Subject: Hendrickson 5 Inch Drop Axle Tie Rods

Models Affected: Specific Freightliner Cascadia vehicles manufactured April 30, 2012, through May 26, 2015, equipped with Hendrickson 5 inch drop axle tie rods, brake linings, and stamped spiders.

Recall Campaign

April 2019 FL807A-D NHTSA #19V-093 Transport Canada #2019-066

Fig. 1, Tie Rod Assembly

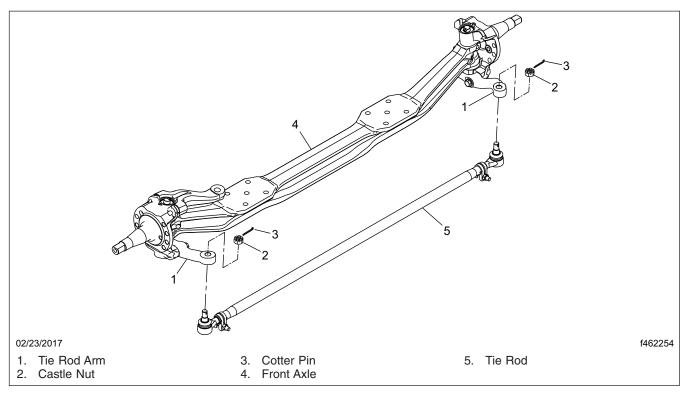
- Remove the brake assembly. Refer to the applicable section in Group 42 of the Cascadia Workshop Manual.
- 7. Disconnect the tie rod from the tie rod arms; see Fig. 1. Remove the tie rod from the vehicle and discard it.

- 8. Attach a new tie rod to the tie rod arms. Tighten the castle nut 120 to 170 lbf-ft (163 to 230 N·m) plus a maximum of one-sixth of a turn to align a slot in the castle nut with the cotter pin hole in the tie rod stud. Insert the cotter pin and bend the tangs to secure it.
- 9. Clean and inspect all brake parts that will be reused. Refer to the applicable section in **Group 42** of the *Cascadia Workshop Manual*.
